PIC24FJ64GA104 Family Silicon Errata and Data Sheet Clarification

The PIC24FJ64GA104 family devices that you have received conform functionally to the current Device Data Sheet (DS39951C), except for the anomalies described in this document.

Data Sheet Clarifications

FIGURE 2-3 FREQUENCY vs. ESR PERFORMANCE FOR SUGGESTED VCAP

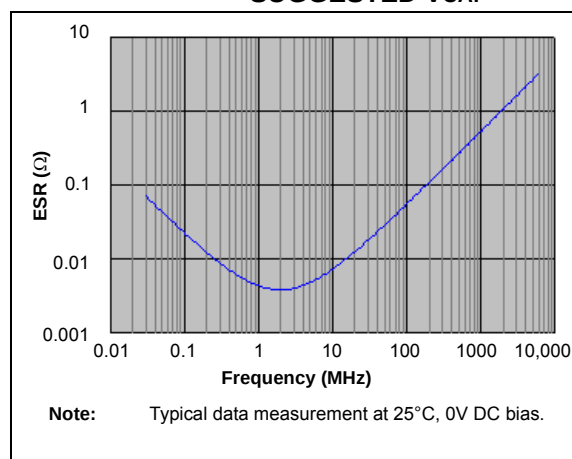
Section 2.4 Voltage Regulator Pins (ENVREG/ DISVREG and VCAP/VDDCORE) has been replaced with a new and more detailed section. The entire text follows:

When the regulator is enabled, a low-ESR ($< 5\Omega$) capacitor is required on the VCAP/VDDCORE pin to stabilize the voltage regulator output voltage. The VCAP/VDDCORE pin must not be connected to VDD and must use a capacitor of 10 μF connected to ground. The type can be ceramic or tantalum. Suitable examples of capacitors are shown in [Table 2-1](#). Capacitors with equivalent specifications can be used.

Designers may use [Figure 2-3](#) to evaluate ESR equivalence of candidate devices.

FIGURE 2-4 DC BIAS VOLTAGE vs. CAPACITANCE CHARACTERISTICS

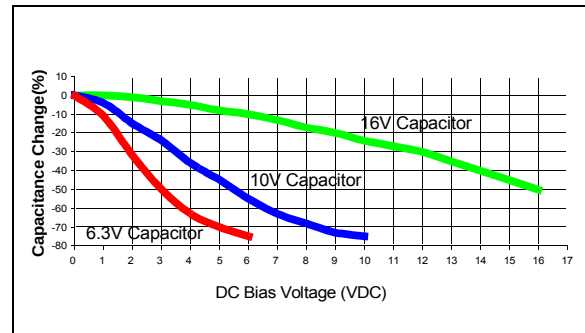
In addition to temperature tolerance, the effective capacitance of large value ceramic capacitors can vary substantially, based on the amount of DC voltage applied to the capacitor. This effect can be very significant, but is often overlooked or is not always documented.

A typical DC bias voltage vs. capacitance graph for 16V, 10V and 6.3V rated capacitors is shown in Figure 2-4.

When selecting a ceramic capacitor to be used with the internal voltage regulator, it is suggested to select a high-voltage rating, so that the operating voltage is a small percentage of the maximum rated capacitor voltage. For example, choose a ceramic capacitor rated at 16V for the 2.5C core voltage. Suggested capacitors are shown in Table 2-1.
